NRC DOCKETS 50-321, 50-366
OPERATING LICENSES DPR-57, NPF-5
EDWIN I. HATCH NUCLEAR PLANT UNITS 1, 2
NRC I&E BULLETIN 80-11

NRC I&E BULLETIN 80-11, "MASONRY WALL DESIGN"

RESPONSE TO NRC REQUEST FOR
ADDITIONAL INFORMATION

EDWIN I. HATCH NUCLEAR PLANT

Project	HATCH-UNIT NO. 1 & 2	Prepared By	TINA C. SALTER	Date	11-19-80
Subject/Title	WALL MODIFICATION	Reviewed By	K. L. WILKINSON	Date	11-21-80
C-130-3A & 3B (PSOC-80-003)			Calculation Number	Sheet	5 of 9

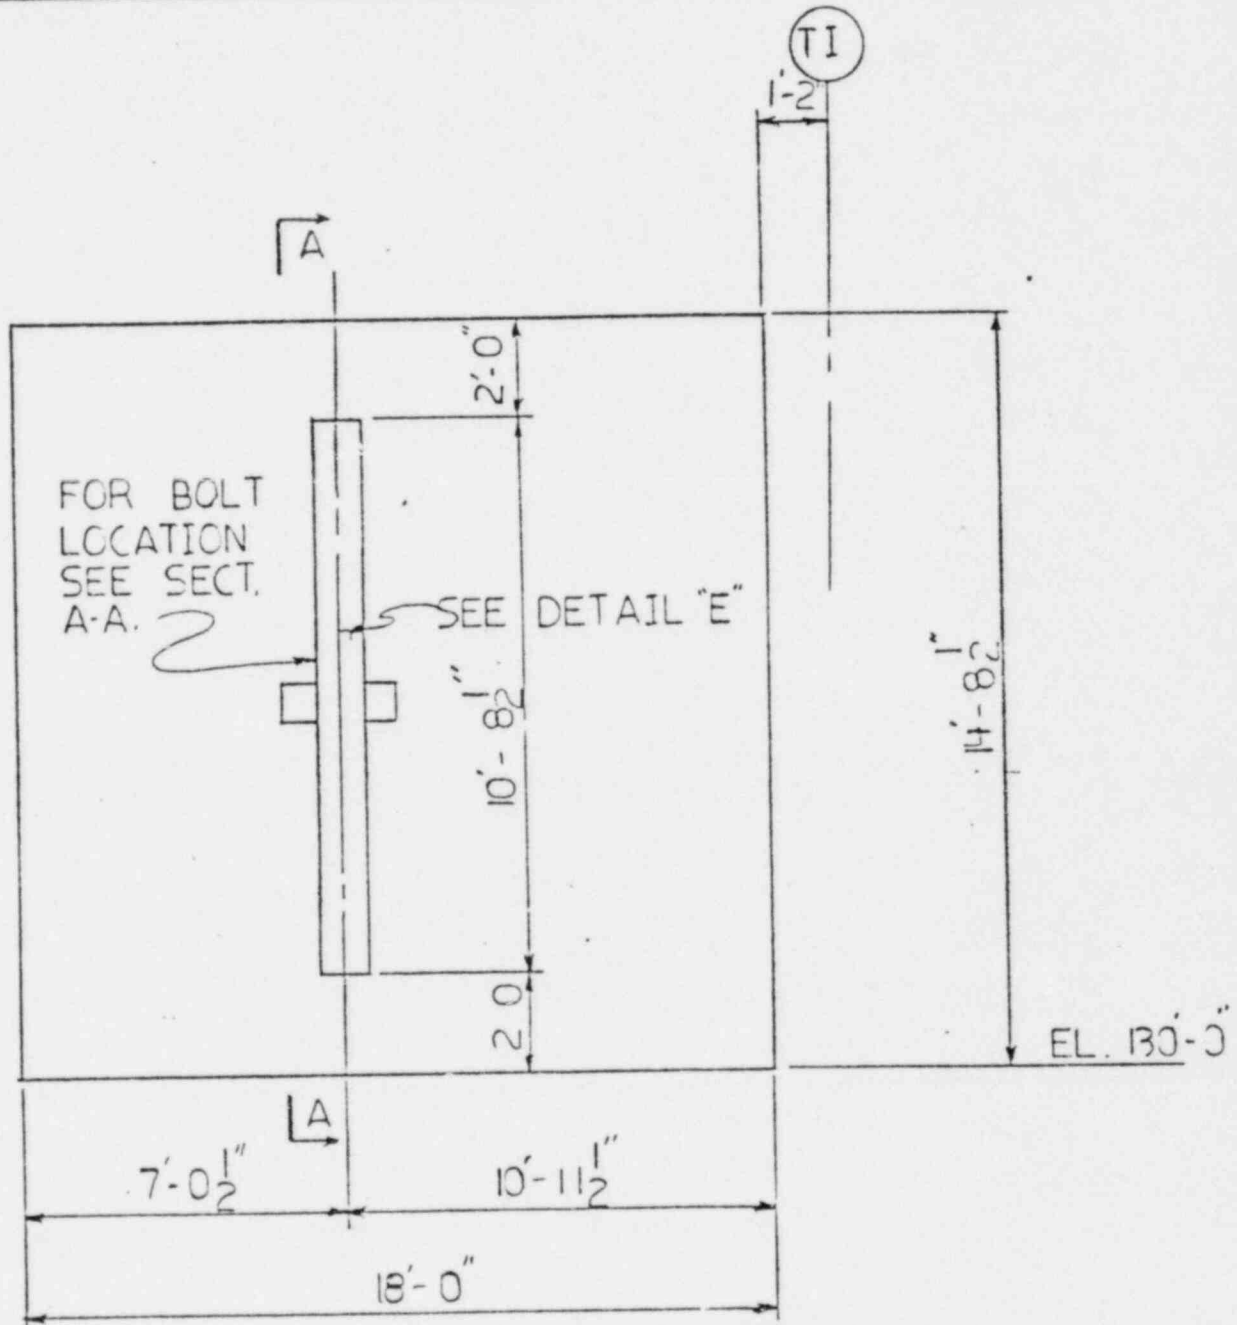
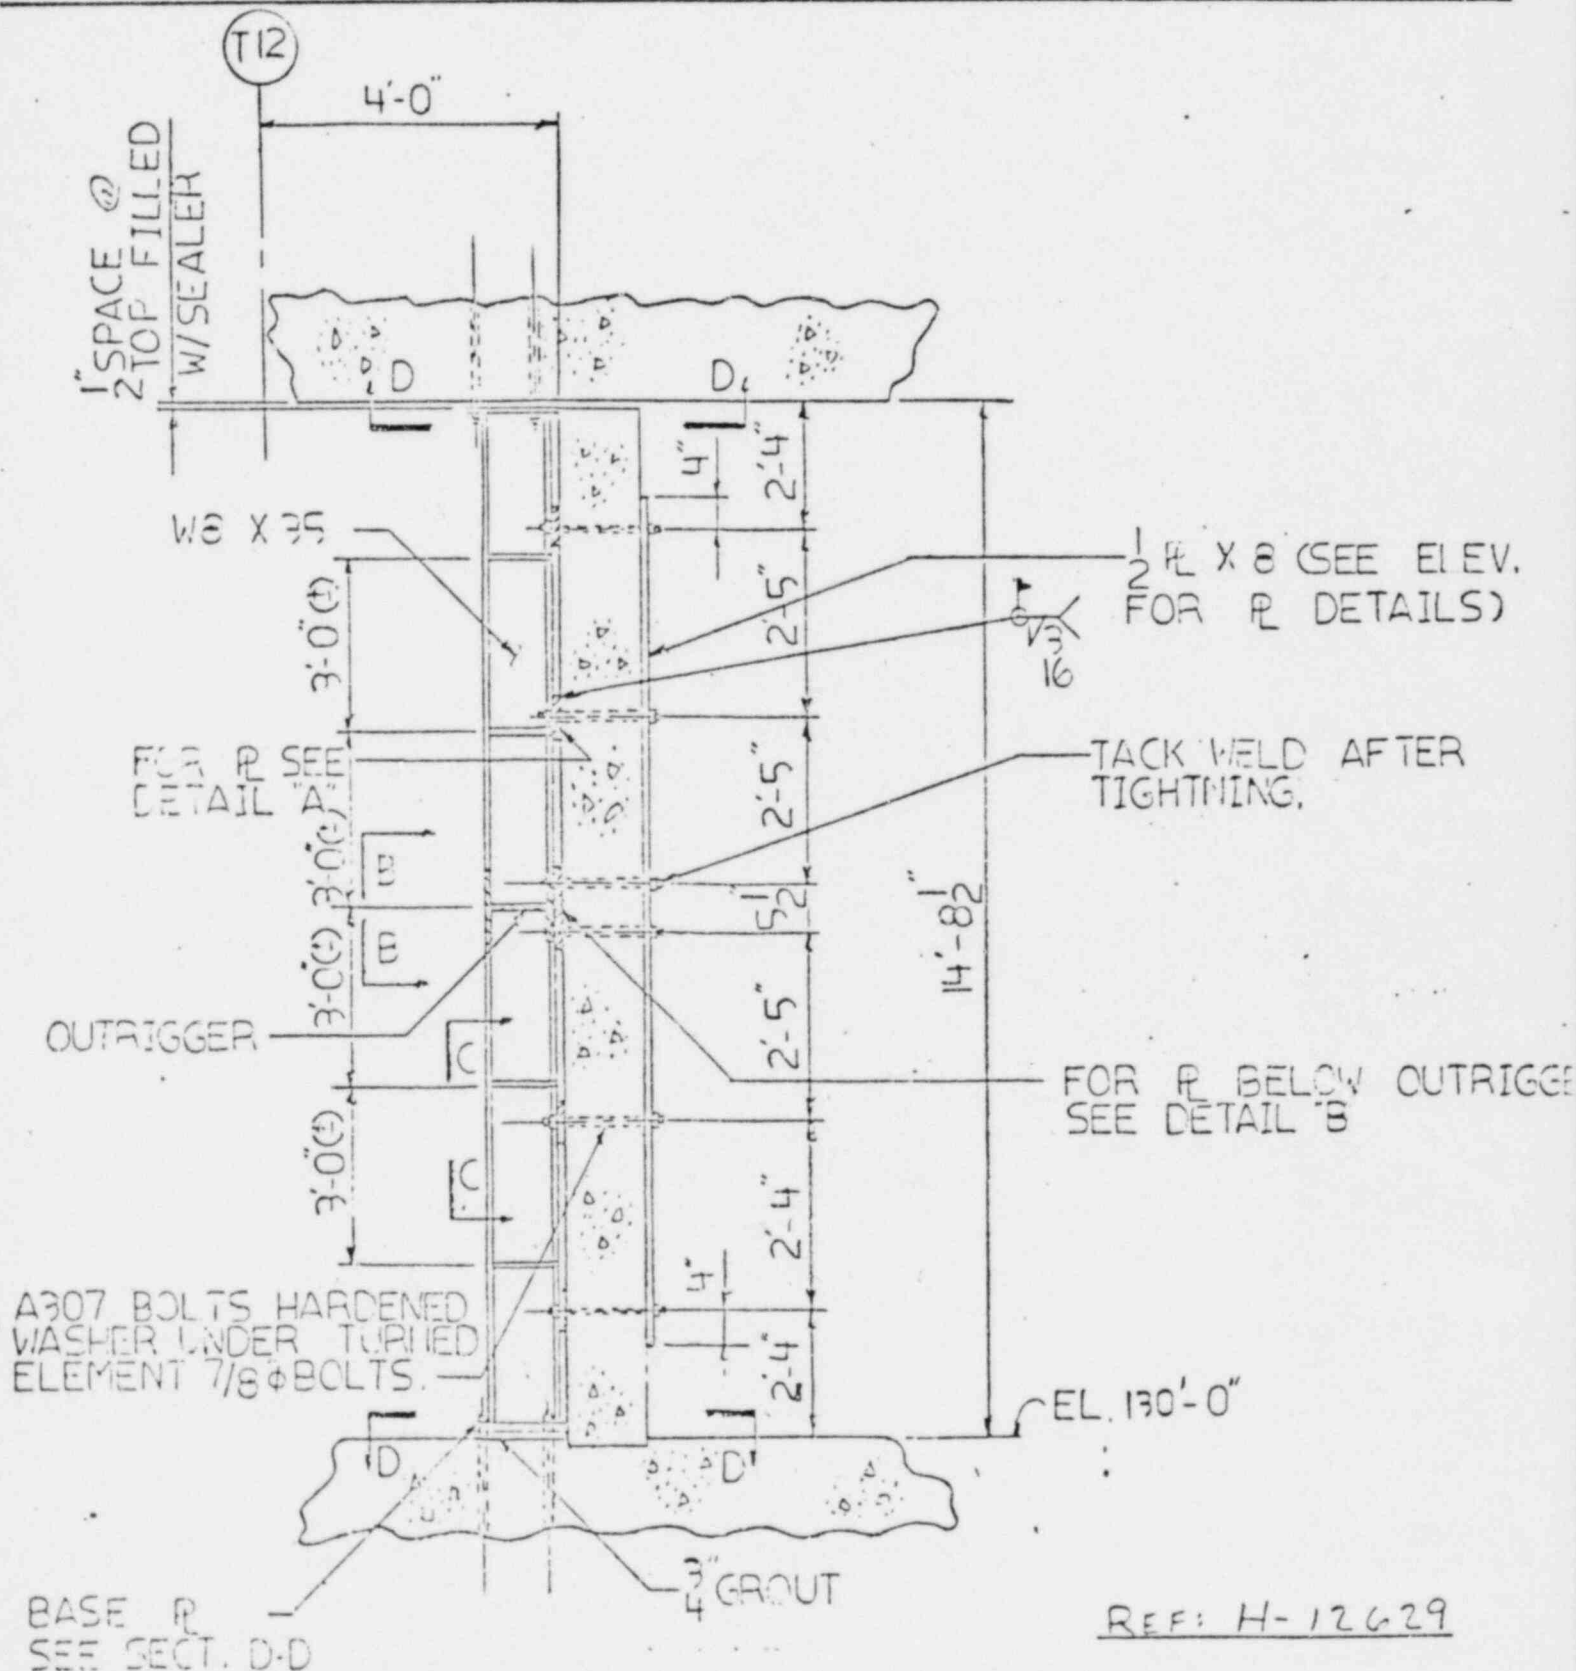
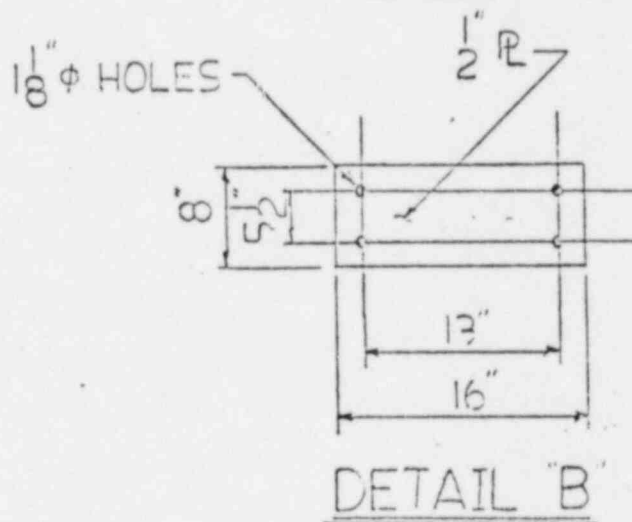
Provide details of modifications for all walls that do not satisfy the design allowables. Technical discussion should be provided detailing how these modifications will correct this deficiency. Also, provide the modification schedule.

A number of walls were modeled for STRUDL-DYNAL and had a finite element analysis run of the as-built condition, taking into account all loads and load combinations. A total of ten (10) walls were identified where calculated stresses exceeded allowable stresses. The results of the analysis showed that the effective horizontal span length of the wall should be reduced. Therefore, a point somewhere within the middle one-third of the span of the wall was chosen considering obstructions and installation problems, and one or more structural steel columns were erected to provide additional support for the wall. The column(s) were designed to withstand the applied loads and were used to brace the wall as shown in the attached sketches. The wall was then re-modeled for STRUDL-DYNAL, including the steel column, and a finite element analysis was performed again for all postulated loads and load combinations. Resulting moments and shears for the masonry wall and support column were checked against allowables. In addition, bolts, plates, and welds for the support having an angle brace were checked for worst-case loads. Wall number C130-14A&B had an angle brace attached to the ceiling on each side of the wall to provide lateral shear support and reduce a local overstress condition to within allowables. Following the analysis using the modified models, each wall was determined to satisfy all stress allowables.

Detailed sketches of the modification for each wall are shown in attachments 1 through 8. The field modifications for each wall are complete except for wall C164-4A&B and wall C130-39A&B. Both of these walls will be removed in the near future to allow for relocation of the shift supervisors office and modifications in the health physics area. Therefore, no modifications have been scheduled for these walls.
